7/1
GOVERNMENT OF MADRAS.

PUBLIC WORKS DEPARTMENT.

5th January 1882, No. 7 W.

JANUARY.
Nos. 13-14.Revenue Board Latrine, Chempak. — Intimat-
ing that the nuisance complained of is
owing to improper conservancy, which
should receive careful attention.Letter from the Examiner, P. W. Accounts
No. 143 W dated 19th October 1881FOR ORDERS.

Sketch
Shown Proposed
New site for Latrine
for
Revenue Board office

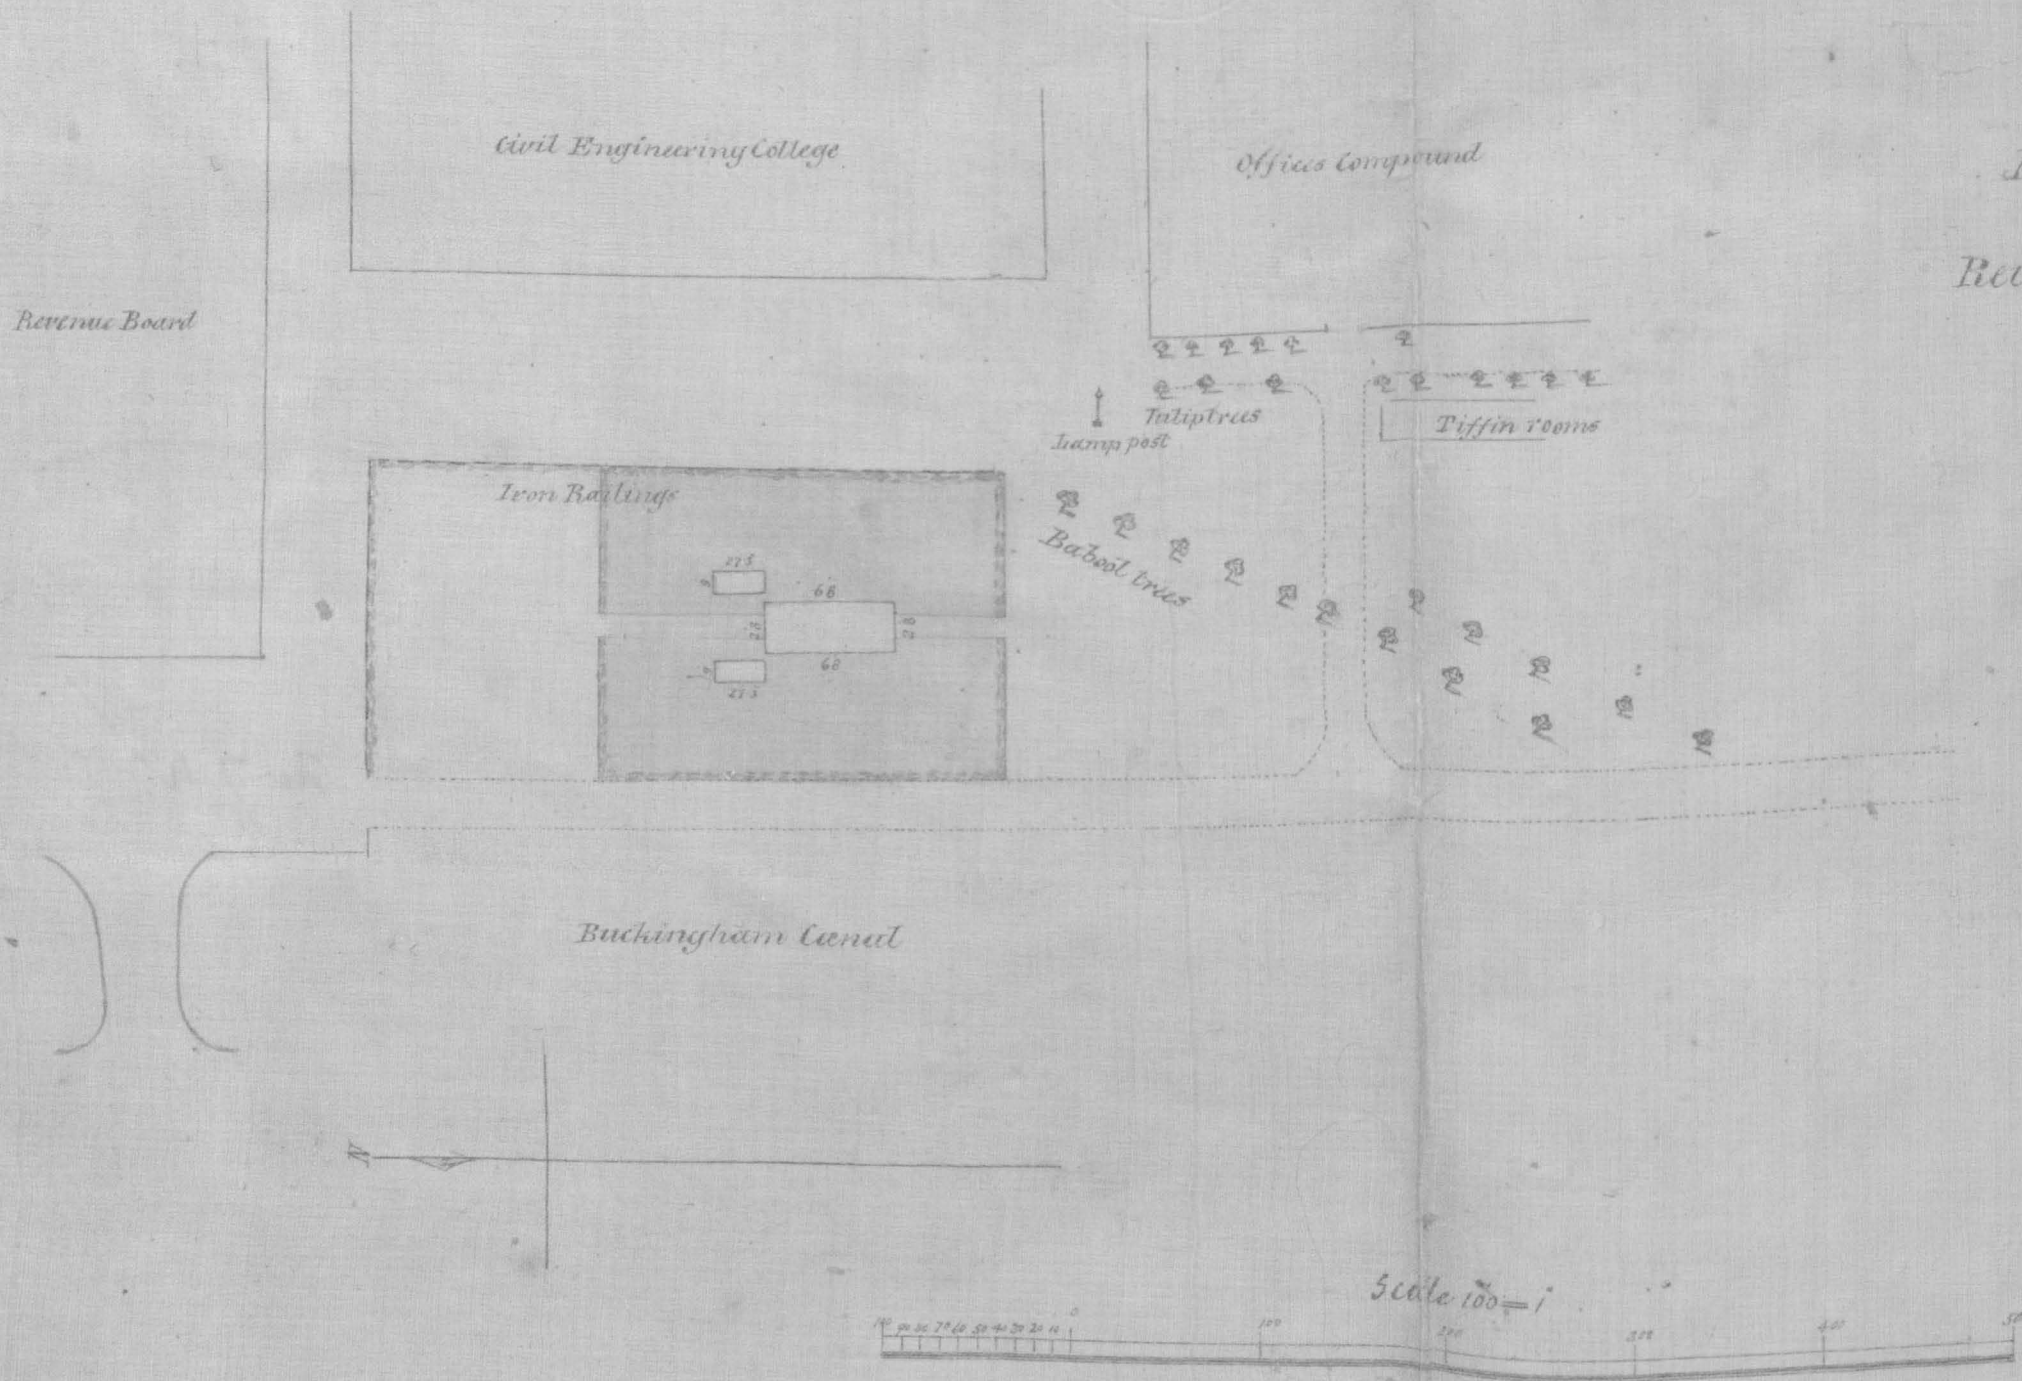
objections for the latrine for the Revenue Board buildings. Lieutenant-Colonel Burton writes, that a site less objectionable than any other which could be found is the plot of ground to the west of the Civil Engineering College, and lying between the road running to the west of this building and the road along the east bank of the Buckingham Canal, as shown on the enclosed sketch in green.

2. I am of opinion that this site cannot be appropriated for the purpose, as the position is most conspicuous from the buildings on two sides, and even from the bridge over the canal. I believe the chief fault of the present arrangement is with the conservancy; if this were looked to, and dry earth freely used, the nuisance would be at any rate much abated.

2. I am of opinion that this
side cannot be appropriated for the
purpose, as the position is most con-
spicuous from the buildings on two
sides, and even from the Bridge over
the Canal. I believe the chief
fault of the present arrangement is
with the Conservancy; if this were
looked to, and dry earth freely
used, the nuisance would be
at any rate much abated.

THE Government concur with the Superintending Engineer in thinking that the conservancy is at fault. This should receive careful attention.

The Government
concur with the Supt.
Engineer in thinking
that the Conservancy
is at fault. This
should receive careful
attention.
